VILLAS AT CLAREMONT

LETTER OF INTENT

DECEMBER 2020

LOI V_1 planning redlines only.pdf Markup Summary 2-16-2021

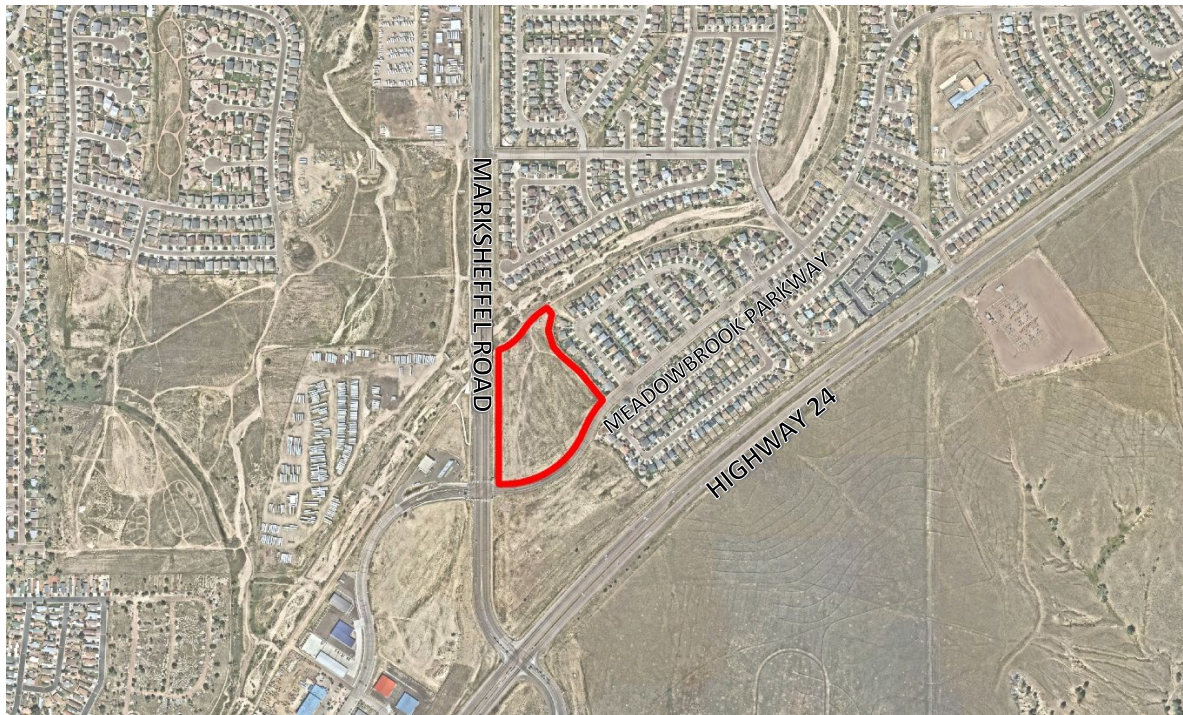
How many acres is the SKP amendment? The revised road alignment is splitting what was to be commercial on the drawing, is the remaining portion to remain commercial?

minor amendment will be admin as agreed to in EA and will not be seen by BOCC or PC... A concurrent request for the PUDSP will carry forward to PC and BOCC. This SKP request should likley stand alone since it will be approved a month before the PC is scheduled for the PUDSP... to avoid confusion w hearing bodies who will not be asked to approve the SKP

Any modifications requested? Please state and justify based on the Criteria for approval for the BOCC to approve the requested modifications if the LOI is to remain the same for all applications

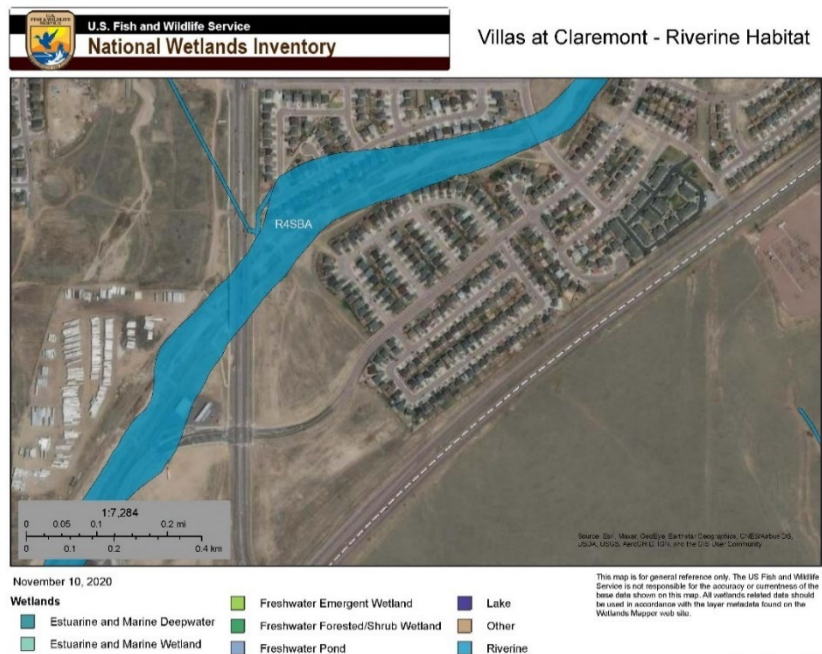
What does 5 high mean? Where would this be located, installed by, and maintained by? Did the airport ask for additional items in their comments?
